**MONTGOMERY COUNTY HISTORIC PRESERVATION COMMISSION**  
**STAFF REPORT**

<b>Address:</b>	7209 Willow Avenue, Takoma Park	<b>Meeting Date:</b>	8/14/2024
<b>Resource:</b>	Outstanding Resource Takoma Park Historic District	<b>Report Date:</b>	8/7/2024
<b>Applicant:</b>	Tina Crouse	<b>Public Notice:</b>	7/31/2024
<b>Review:</b>	HAWP	<b>Tax Credit:</b>	No
<b>Permit Number:</b>	1077703	<b>Staff:</b>	Chris Berger
<b>PROPOSAL:</b>	Solar panel installation.

**Figure 4:** The site plan (left) shows the proposed solar panel locations and the building’s orientation toward Willow Avenue. The roof plan (right) shows the proposed location of the solar panels and the equipment location on the left-side elevation near the front wall plane.

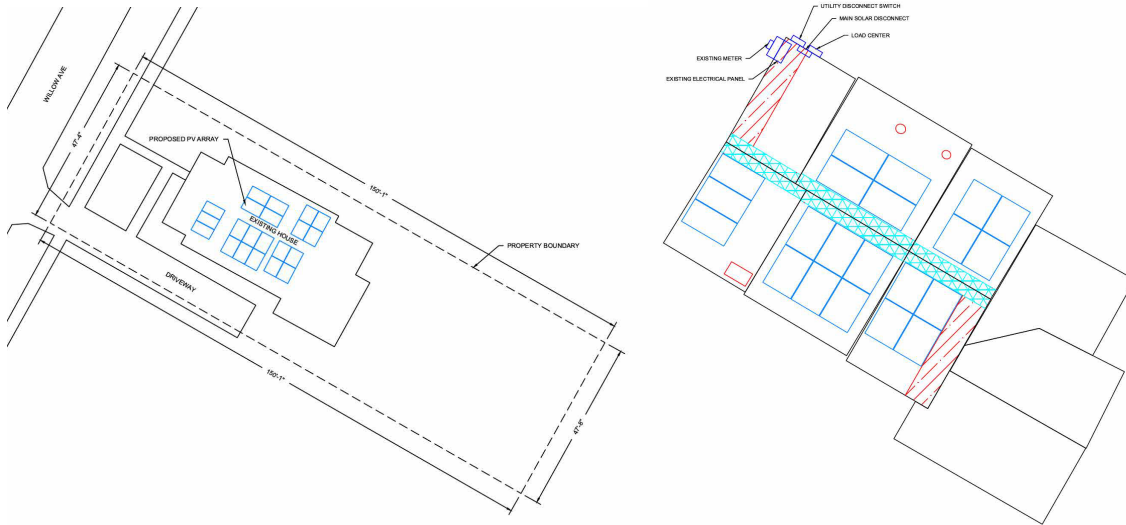
1. The three panels proposed toward the front wall plane cannot be installed. The applicant has the option to instead install panels on the one-story rear additions but only after staff reviews and approves a revised plan.
2. The applicant must provide a plan to show how the conduit will extend from the load center to the panels on the roof. The conduit cannot damage the eaves.

However, staff does not support the installation of the three panels proposed for installation closest to the front wall plane. As an Outstanding Resource, the *Guidelines* instruct that the subject property is to receive the most detailed level of design review. Unlike the 18 panels proposed farther back on the roof, these three panels at the roof's edge toward the front wall plane will be more readily visible to passers-by who are traveling northbound in the Willow Avenue right of way. The three panels will be prominently visible from the right of way—located approximately 25 feet away—and the proposed placement of the

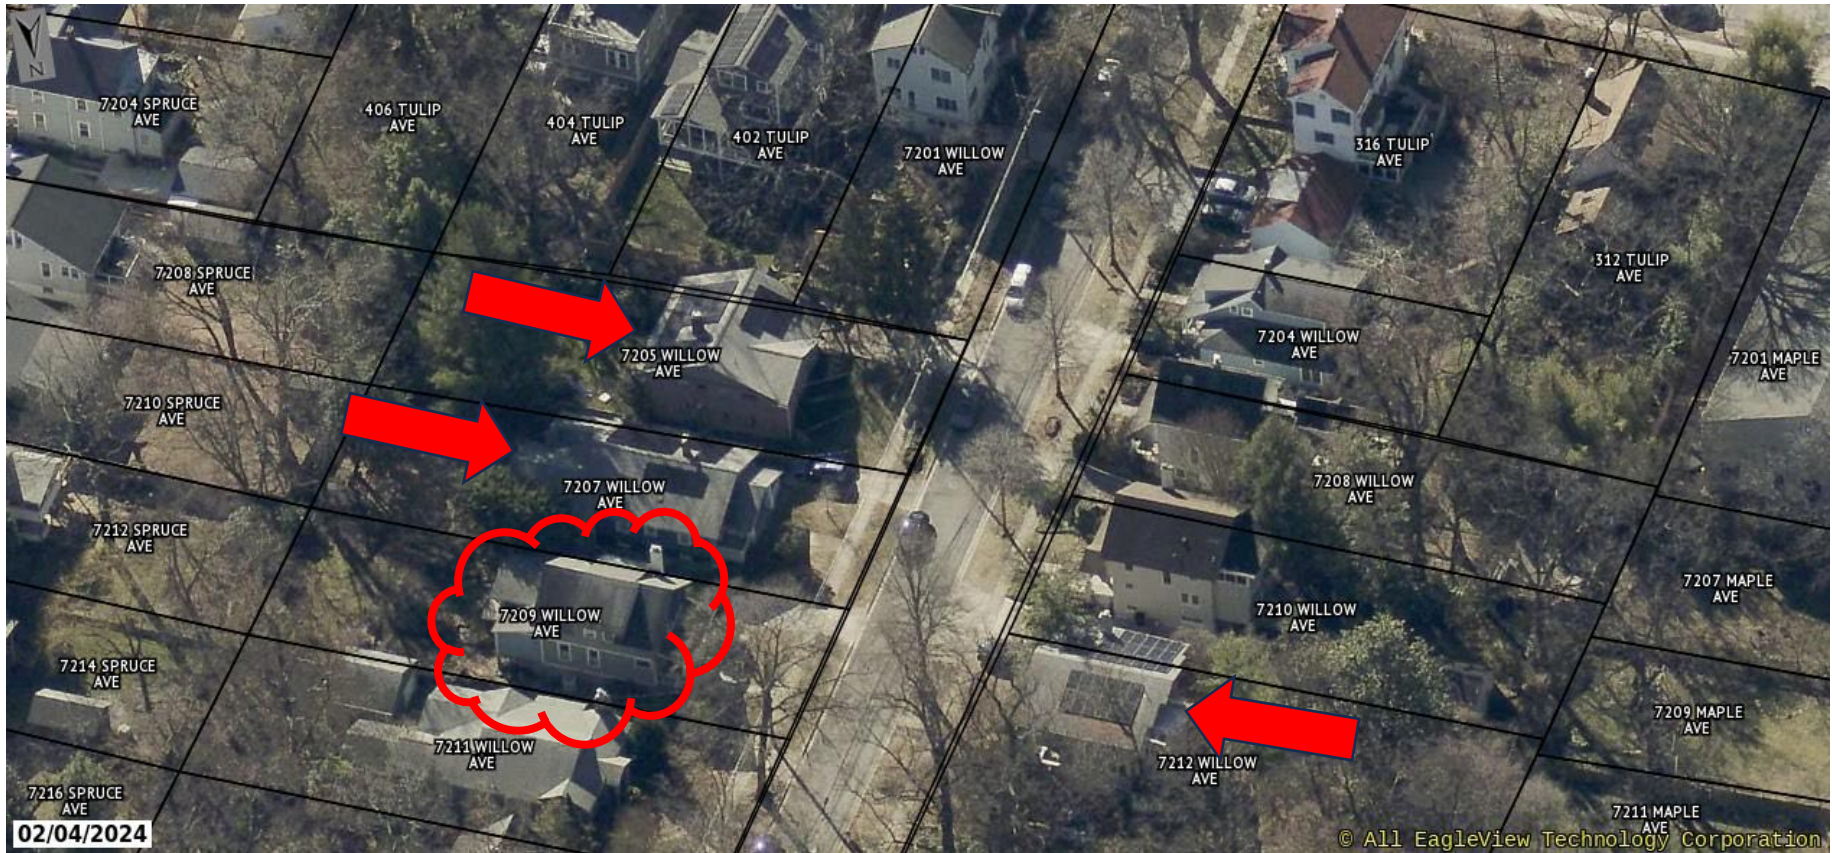
Solar panels are an established feature on the roofs of nearby residences, but in all instances the panels were set back from the wall plane to minimize visibility, unlike what is proposed for the three panels at the subject property (*Figure 8*). In 2022, the HPC staff approved 34 panels on the roof of the Outstanding Resource across the street from the subject property at 7212 Willow Ave. with HAWP #988569.<sup>1</sup> Staff had the authority to approve because the panels, which were set back from the roof edge, because they were not to be readily visible from the right of way. At its November 15, 2023, meeting the HPC approved the installation of 28 solar panels on the Contributing Resource next door to the subject property at 7207 Willow Avenue with HAWP #1046207 (*Figures 6-7*).<sup>2</sup> The building, a one-story Craftsman style Bungalow, has a front-oriented gable roof with panels installed to either side that are visible from the right of way. The solar equipment and conduit is located on a side elevation close to the front wall plane, similar to what is proposed at the subject property at 7209 Willow. The Non-Contributing Resource at 7205 Willow Ave. also has panels visible from the right of way, and they too are set back a few feet from the front roof edge.<sup>3</sup>
